Generic Design Assessment – New Civil Reactor Build

**Step 4 Civil Engineering and External Hazards Assessment of the Westinghouse
AP1000[®] Reactor**

Assessment Report: ONR-GDA-AR-11-002
Revision 0
11 November 2011

Figure 4: Typical Section Through Shield Building

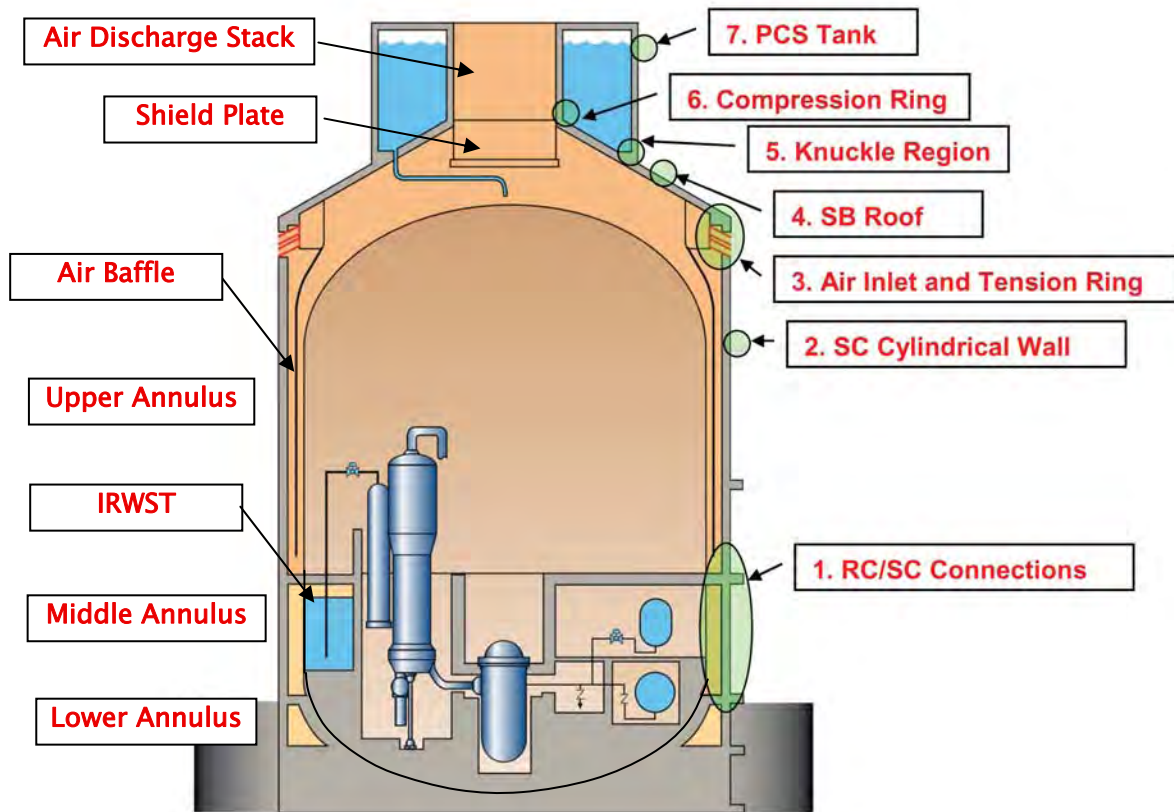
- 488 The layout drawings presented in Section 1.2 of the EDCD indicate that the operating floor inside the CV was connected to it (refer to Figure 4 of this report). I queried this at a civil engineering technical meeting in Pittsburgh in September 2010. Westinghouse confirmed, by demonstrating their 3D model, that the operating floor is supported by steel columns around the perimeter. I am therefore satisfied there is no load transfer to the CV from the operating floor.

Figure 5: Comparison between AP1000 Spectrum and the UK PML Spectra (From Westinghouse response to TQ-952)

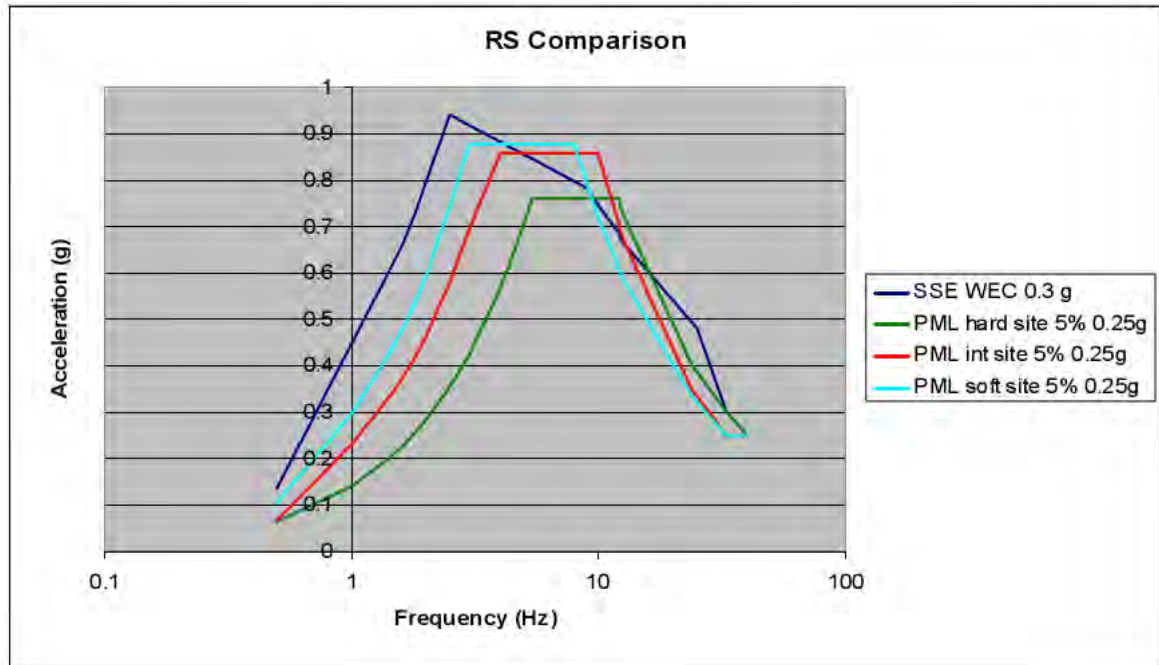
393 Westinghouse’s premise for its generic design is that the enveloped spectra resulting from the Level 1 analyses used will bound the site specific spectra. TQ-AP1000-952 was raised to request evidence showing this was the case for available UK standard spectra. Westinghouse’s response provided the comparison shown below in Figure 5. This shows the AP1000 hard rock horizontal response spectrum against the standard UK spectra for hard, medium and soft sites. These are termed PML spectra since they were developed by Principia Mechanica Ltd in the 1980s and have historically been accepted for application at UK sites.

15Hz, which is a common response range for buildings. Therefore, the AP1000 generic spectrum cannot be considered bounding.

Figure 6: Seismic Ground Motions

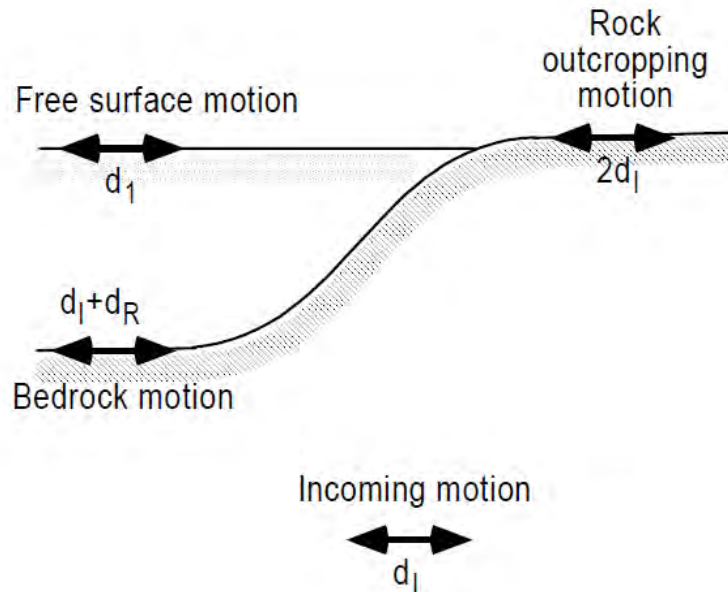
397 Applying a hard rock input motion at ground level to a soft site SSI model is incorrect. Either the hard rock input motion should be applied as the rock incoming motion or the soil site free surface motion should be applied at ground level. Figure 6 below illustrates this.

- 398 The incoming motion for a hard or soft site should be the same for the same definition of bedrock. This motion is then modified by the soil deposits as it travels to the ground surface (left hand side of Figure 6). Therefore the motion at ground level (free field) will be different for different soil sites. It is well-known that soft soil deposits amplify the incoming rock motion by the time it reaches the surface (Ref. 34).

Figure 9: Comparison of Spectra for two parts of Turbine Building

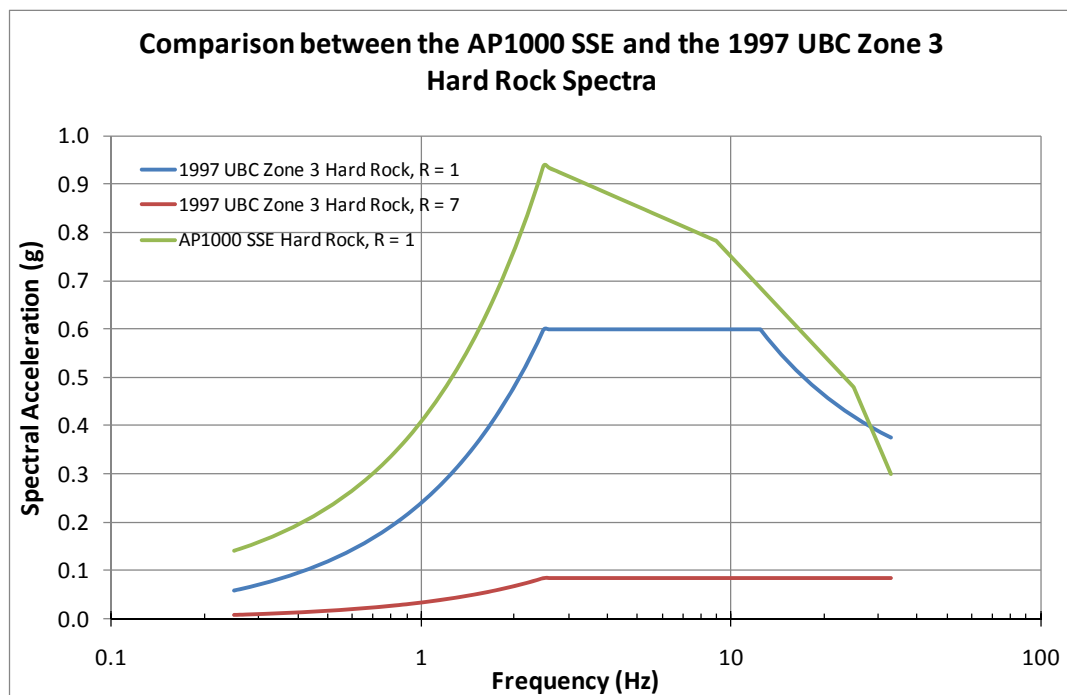
- 439 To illustrate the different earthquake motions, Arup produced a plot (Ref. 34) of the design response spectra for the two sections of the Turbine Building for hard rock sites and for 5% of critical damping. This is repeated as Figure 9 above. The green spectrum is the one used for the first bay. The red spectrum is the one used for the main area. This is compared to the elastic design spectrum of the 1997 UBC (blue spectrum).
